SUPPLEMENTARY REPORT

Panel Reference	2018STH003-Wingecaribee-17/1822
DA Number	17/1822
LGA	Wingecaribee Shire Council
Proposed Development	Concept Plan for Seniors Housing and Stage One – 52 self care seniors housing dwellings.
Street Address	2 – 18 Centennial Road, Bowral, Lots 1-2 DP1101892 and Lots 4-11 DP1109214
Applicant/Owner	Waterbrook Bowral
Number of Submissions	Not applicable to supplementary report
Regional Development Criteria (Schd 4A of the Act)	Clause 3 General development over \$20 million
List of all relevant s4.15(1)(a) matters	<ul style="list-style-type: none"> • Water Management Act 2000 • SEPP (Housing for Seniors or People with a Disability) 2004 • SEPP No. 55: Remediation of Land • Wingecaribee Local Environmental Plan 2010 • Bowral Town Plan DCP v.9
List all documents submitted with this report for the Panel's consideration	<ol style="list-style-type: none"> 1. Final Conditions 2. Concept Masterplan 3. Bowral Stage 2B Sketch and Dwelling Mis 4. Concept Landscape Plan 5. Existing Tree Plan 6. Redesigned Entry Road 7. Infrastructure Works 8. Typical Road Cross Sections 9. Entry Road Sections 10. Grading and Earthworks Plans 11. Concept Construction Management

Figure 1: Extract of Masterplan Rev H

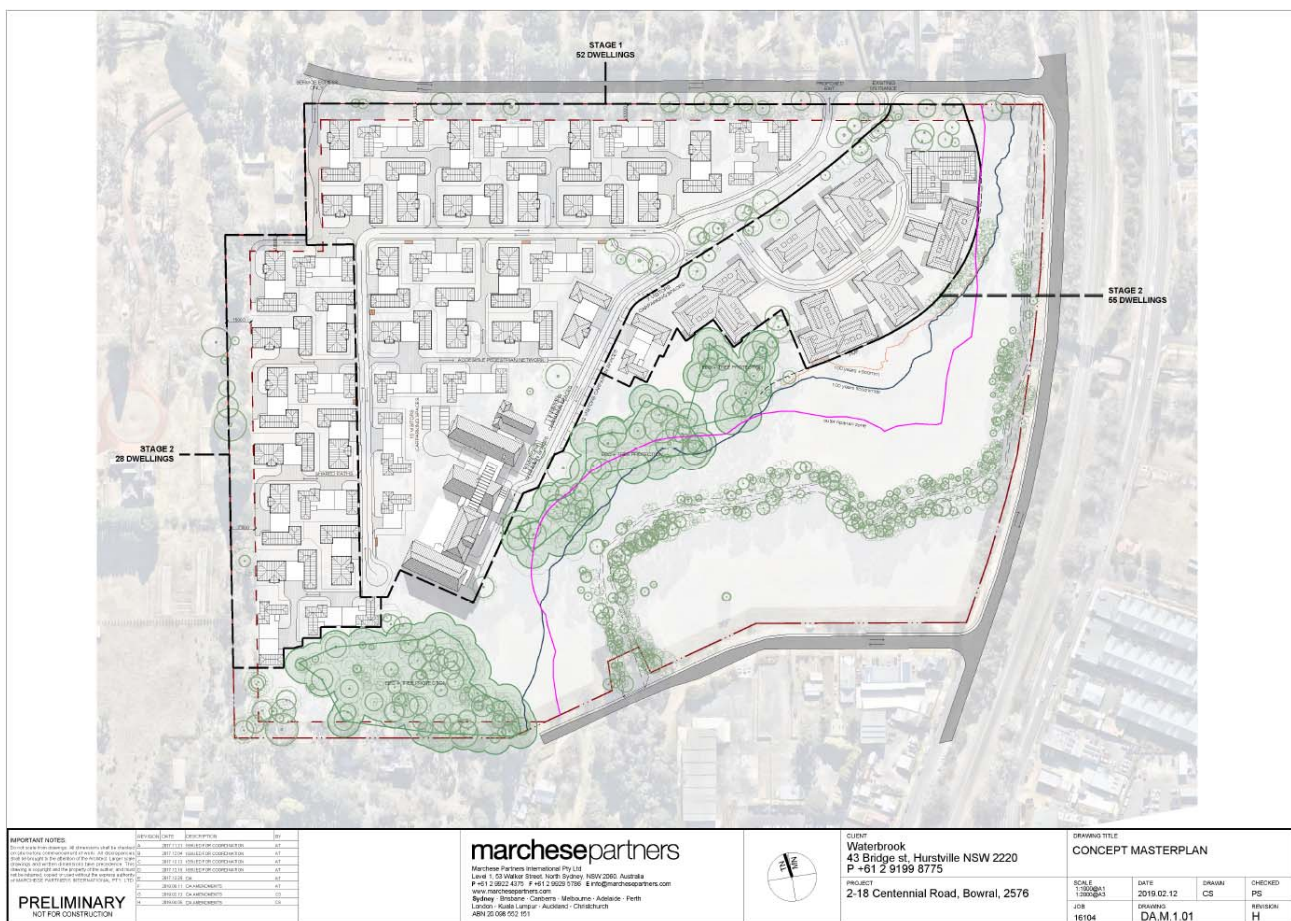
The setback of Stage 2 east buildings from the boundary shared with Centennial Road is a minimum of 30m. The setback from the internal access road is a minimum of 10m. Conditions are recommended to ensure compliance with these minimum setback requirements to allow for substantial separation from roadways and for deep soil planting.

The revised Concept Masterplan Rev H in combination with the concept sketch and development data indicate the scale and density of the eastern portion of Stage 2 do not have the potential to dominate the site with built form and mass.

Figure 2: Ground level self-contained dwellings within Dormer-style manor house

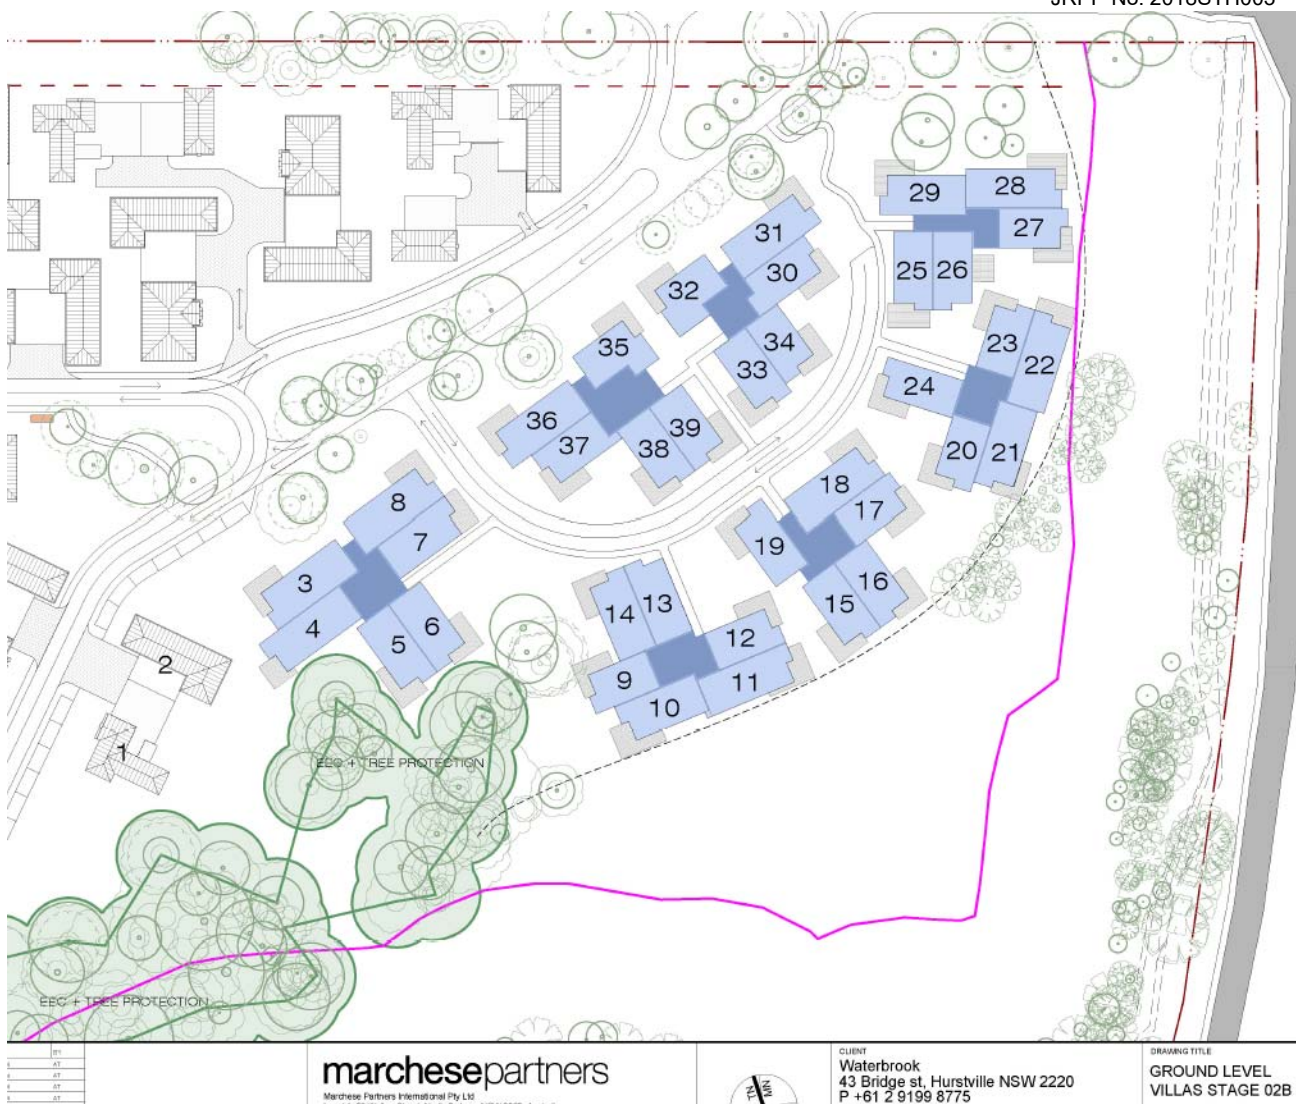
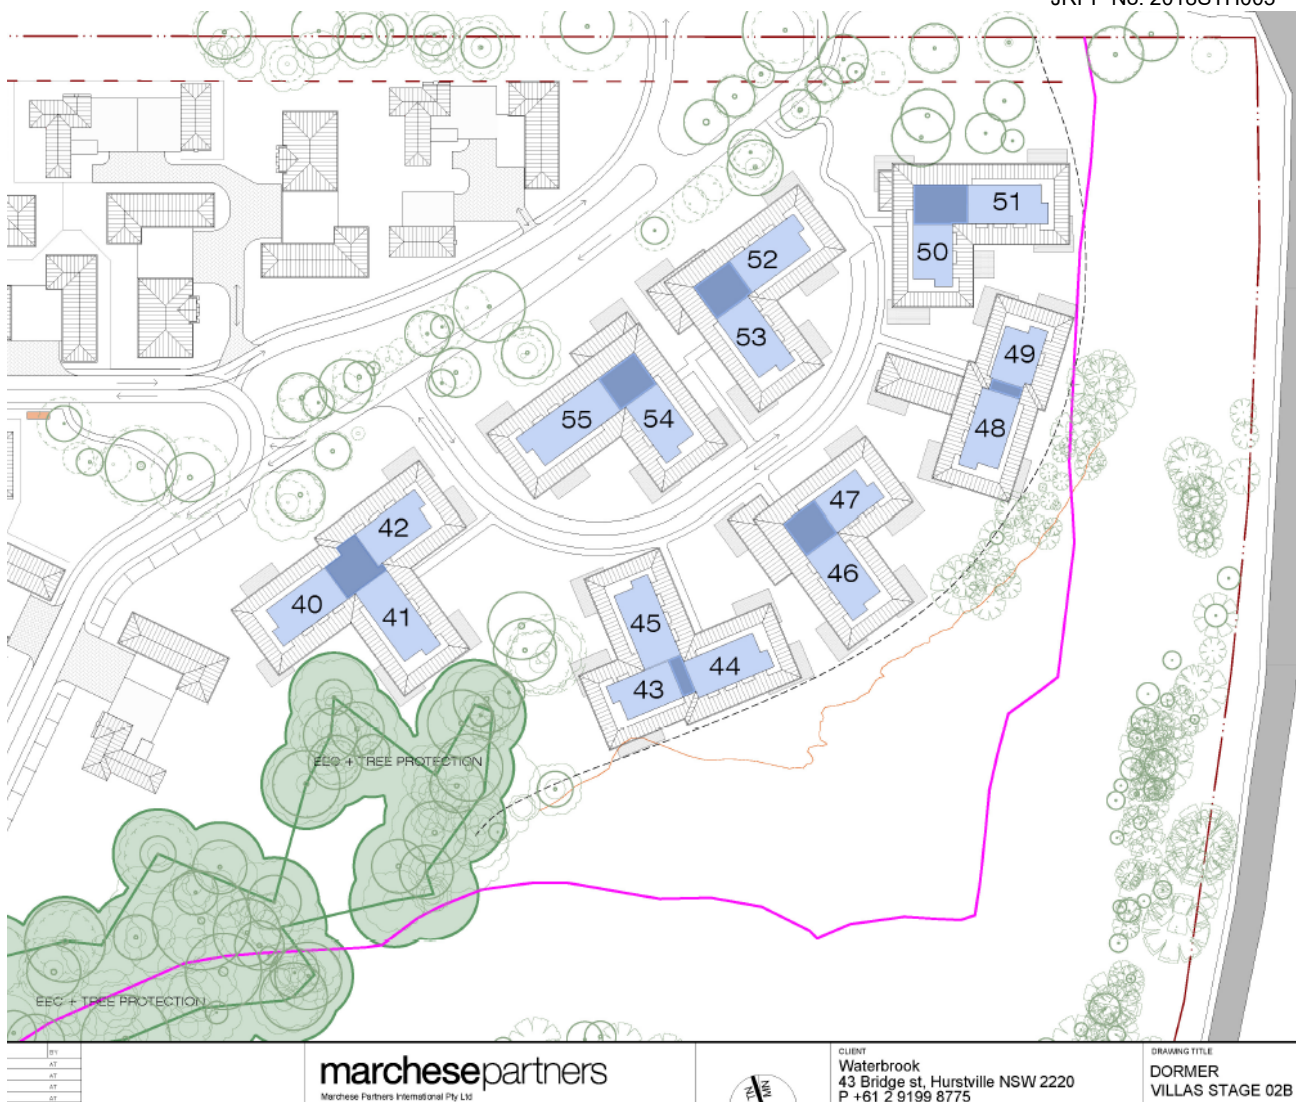
The slope of the site and first floor habitable space being provided in the roof line will require the installation of lifts to achieve accessibility requirements. Lift overruns for Stage 2 east building can be located within the built footprint and building envelope as well as integrated into the roof design such that they are visually concealed. The final design detail will need to be subject to assessment with a future development application. Conditions are recommended that each building is to be provided with a single shared lift only to minimise the potential number of lift overruns overall. The recommended condition states:

“Any lifts for manor house style buildings in Stage 2 east shall be limited to a single shared lift to minimise the number of lift overruns and for the potential of lift overruns to add height, bulk and mass to the buildings.”

Figure 9: Extract from Site Infrastructure Works plan showing internal road hierarchy

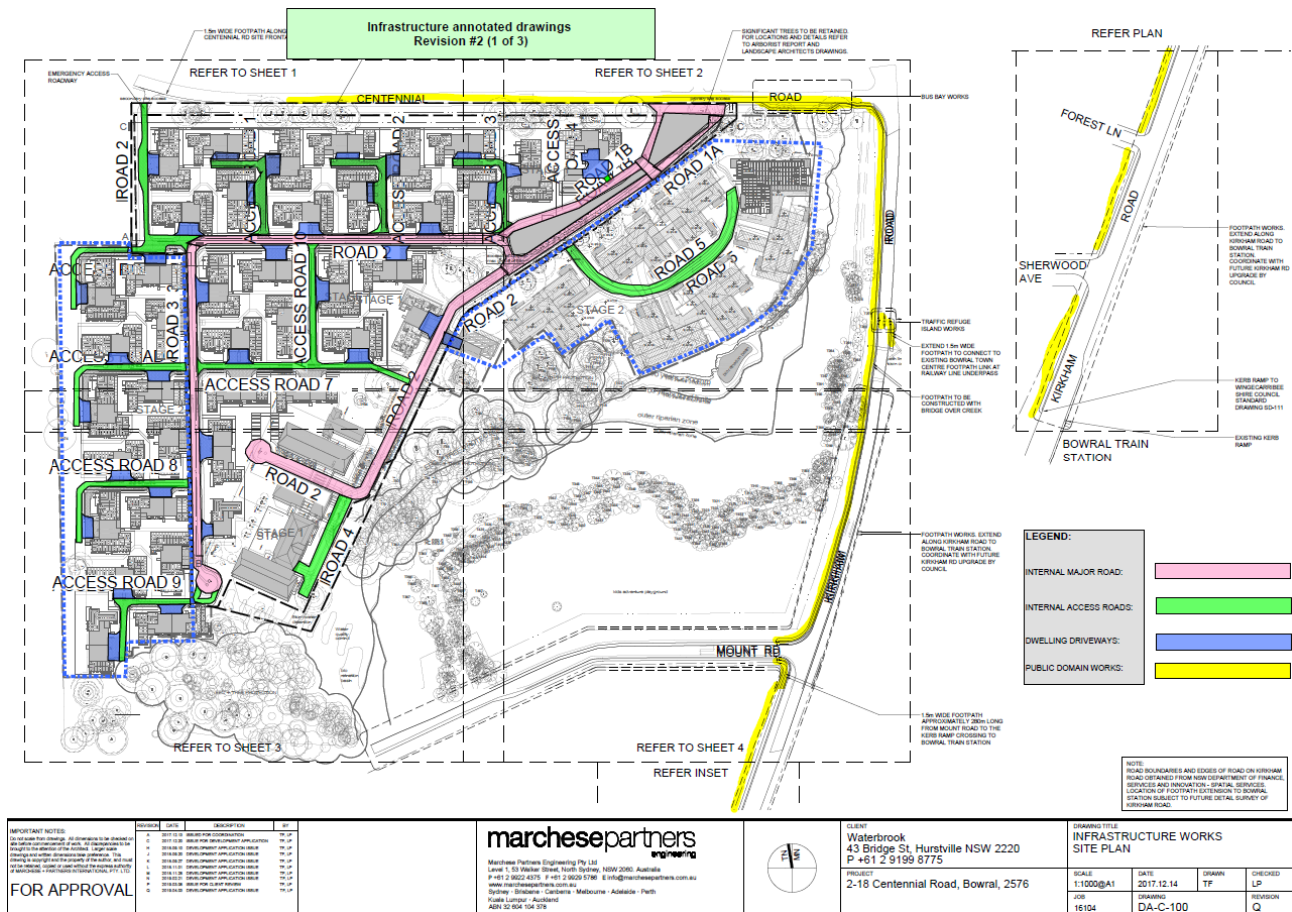
Plans for a new footpath in the public road reserve have been provided in the form of Infrastructure Works Site Plan by Marchese Partners Job 16104 Drawing No.DA-C-100 Revision Q dated 3 April 2019 (see Figure 9). This plan shows provision of a continuous 1.5m wide footpath along the western side of Kirkham Road and the southern side of Centennial Road. The footpath works include pram ramps at the point of crossing the public road network and a pedestrian refuge to access the eastern side of Kirkham Road connecting to the existing footpath network linked to Bowral commercial centre. The footpath also connects safely to Bowral train station as shown on the Inset to the plan.

The footpath will be 280m in length from Mount Road through to the Kerb Ramp crossing to Bowral Station. Two safe crossing points are proposed to the eastern side; one to link with the existing footpath to the east and one at the railway station to link with that footpath. The footpath includes a bridge section to cross the existing creek (which crosses the boundary with Kirkham Road and enters the public road reserve).

Kerb ramps are designed to Wingecarribee Shire Council Standard Drawing SD-111. This plan has been assessed by Council’s Development Engineer and found to be satisfactory. It forms part of the list of recommended approved plans in conditions of consent.

Subject to the inclusion of Infrastructure Works Site Plan by Marchese Partners Job 16104 Drawing No.DA-C-100 Revision Q dated 3 April 2019 being an approved plan with the notice of determination, Deferred Matter 3 has been satisfactorily addressed.

Figure 10: Typical internal road sections (1)

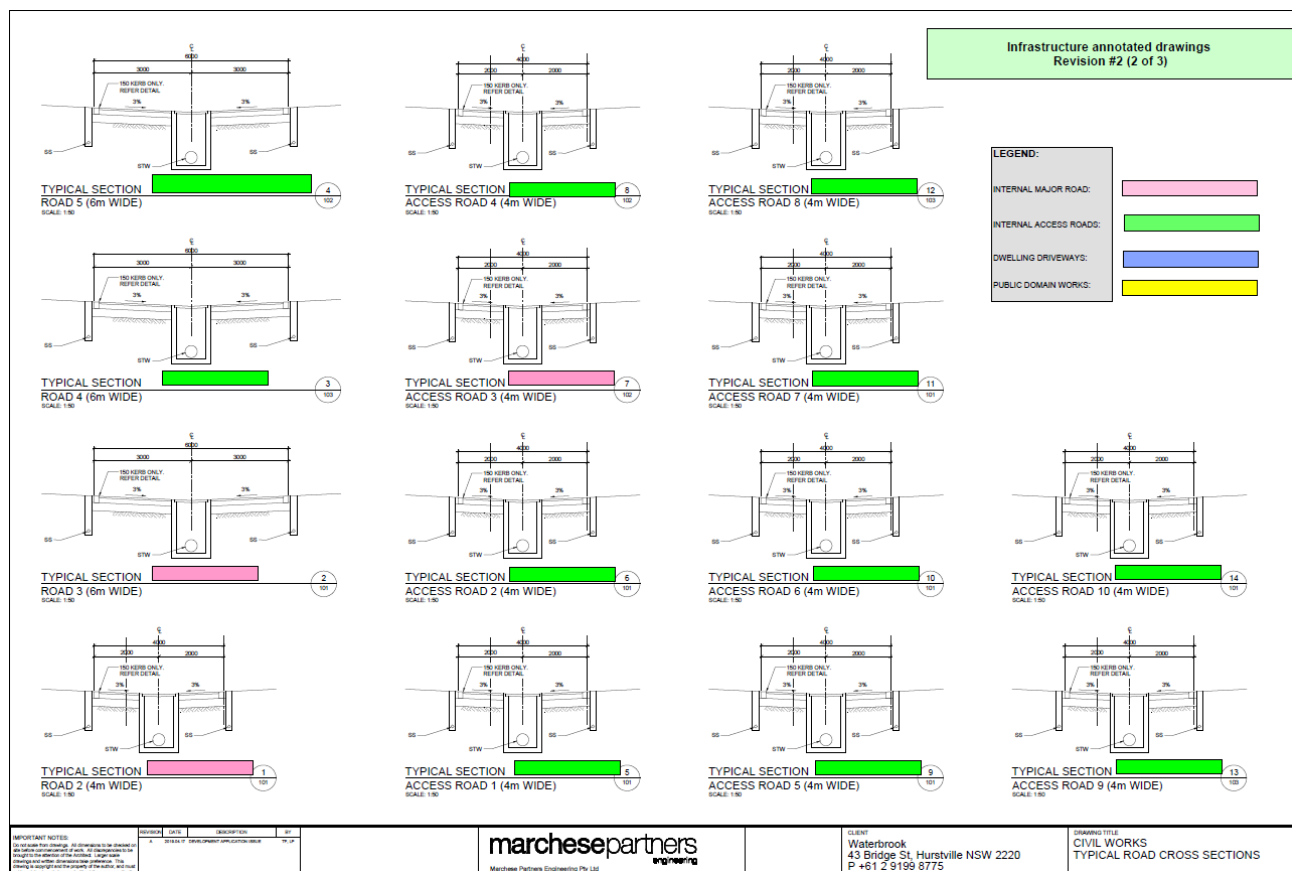
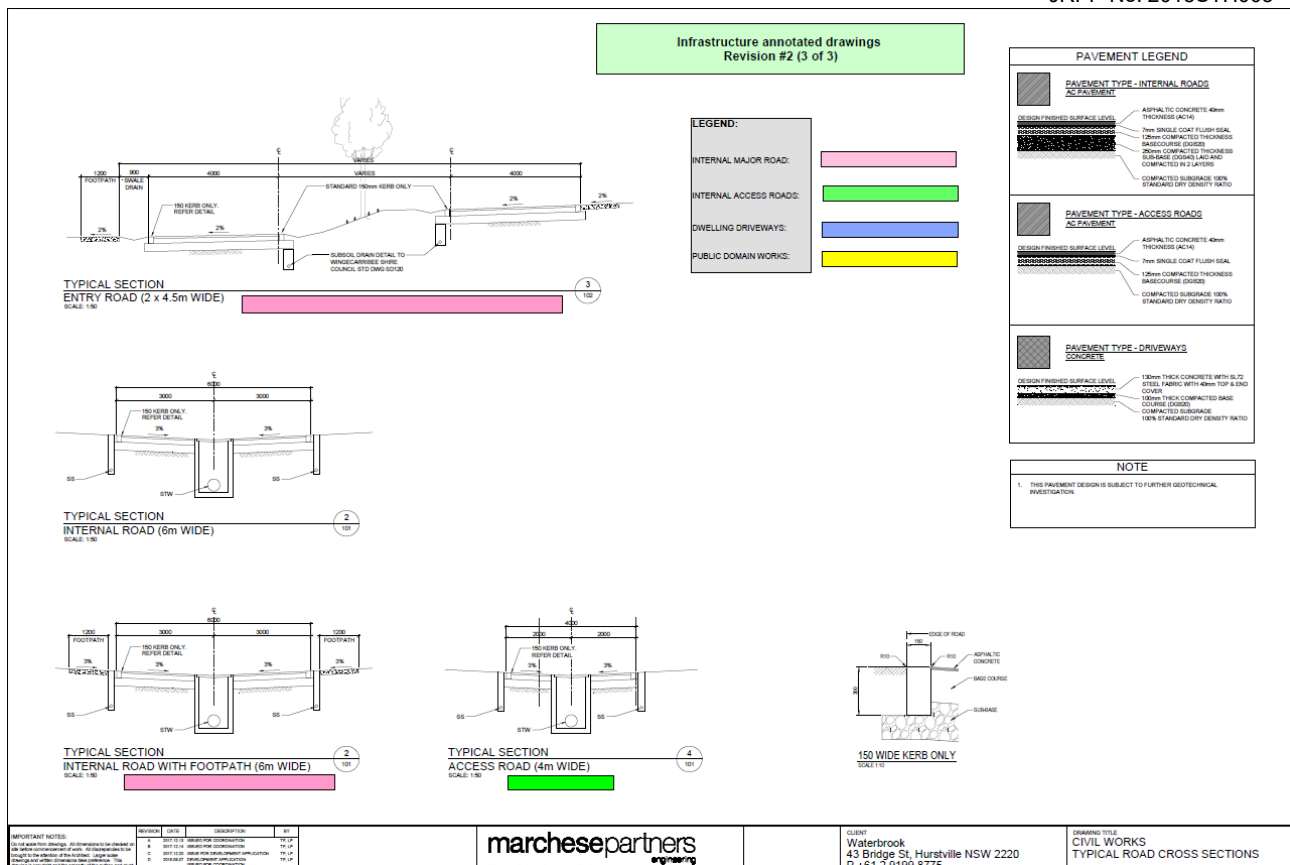
The typical sections show internal roads are to be edged with swales and not provided with raised edge kerb. Council's Tree and Vegetation Officer has advised that swales do not require additional structural support to protect from occasional wheel traverses subject to conditions for the detailed Landscape Plan submitted with the Construction Certificate providing maintenance details for the ongoing inspection and maintenance of grassed verges. The recommended conditions are:

Varga Traffic have provided sufficient information verifying all vehicles can track along swept paths and be contained within the paved surface of internal roads as indicated in the

"The detailed Landscape Plan submitted with the Construction Certificate shall include detail of the regular inspection of grass swales and landscape strips adjacent to the internal vehicle access roads and commitments for regular maintenance (including grass cover and de-compaction of soils) and replacement of landscaping."

Figure 12: Extract from construction management plan and staging plan

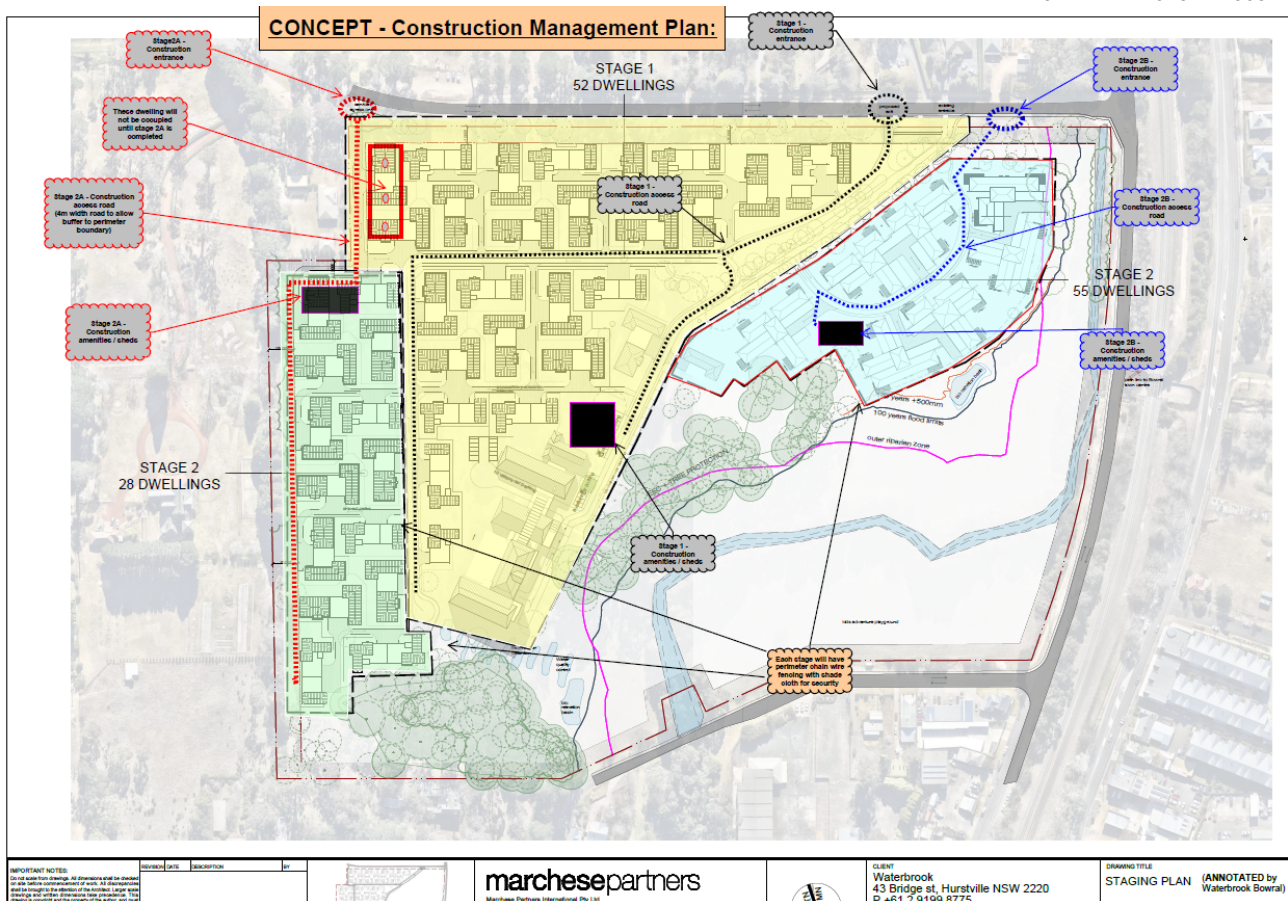
These plans have been reviewed by Council's Development Engineer and determined to be satisfactory.

being approved plans with the notice of determination, the issue of infrastructure installation and staging as part of Deferred Matter 4 has been satisfactorily addressed.
